E6621A-01

S E R V I C E N O T E

E6621A - PXT Wireless Communications Test Set

Downgrading E6621A Software (Firmware) May Affect Instrument Accuracy

[Config], {Ext.IQ Adjust}

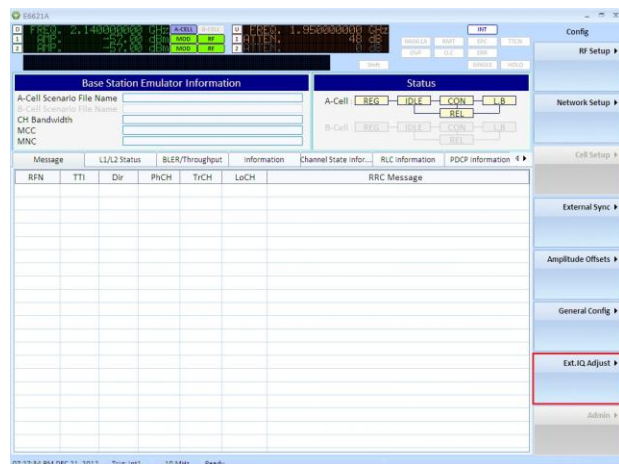
If the “Ext.IQ Adjust” softkey is greyed-out on the front panel display, this indicates that the E6621A calibration data files have been generated using the original method (i.e. pre-dating software release 6.4.2.0).

If the “Ext.IQ Adjust” softkey is accessible (i.e. **not** greyed-out on the front panel display), this indicates that the E6621A calibration data files have been generated using the new method.

In this instance, the software can be downgraded without affecting downlink level accuracy or downlink EVM.

In this instance, the software should not be downgraded – doing so may degrade downlink level accuracy and downlink EVM.
